**November 29, 2017**

**Subject: Comments on the air quality analysis done for the *Sir Francis Drake Boulevard Rehabilitation Project Draft Environmental Impact Report***

Figure 27 Example Scenario East-West Roadway and Receptors Placements for CAL3QHCR

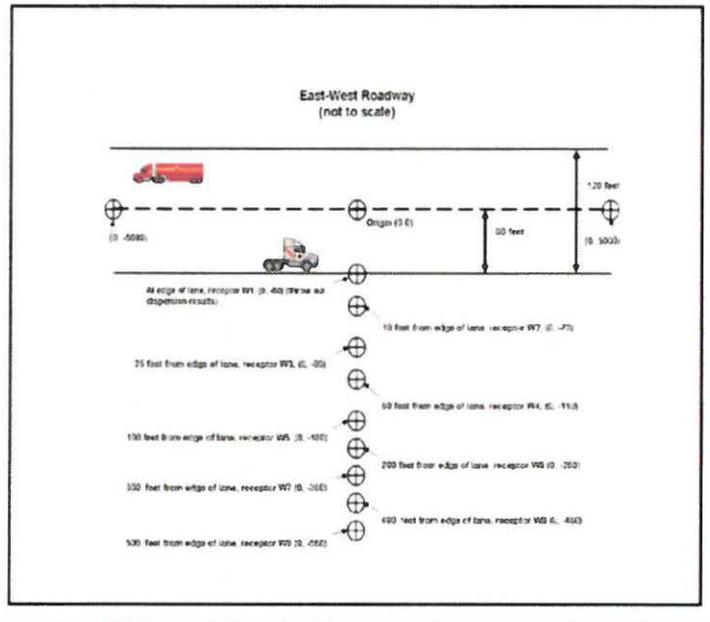
*"Figure 27 [from Risk Modeling Approach, copied below] illustrates the example scenario described in this section ... The District recommends using a receptor grid that encompasses the length of the roadway and has receptors spaced every 50 to 100 meters."*

design. The DEIR must use CAL3QHCR to look at the PM<sub>2.5</sub> levels at sensitive receptors in the roadway corridor by modeling the proposed roadway configuration changes potentially affecting average speeds, idling times at intersections and changes to traffic lane widths.
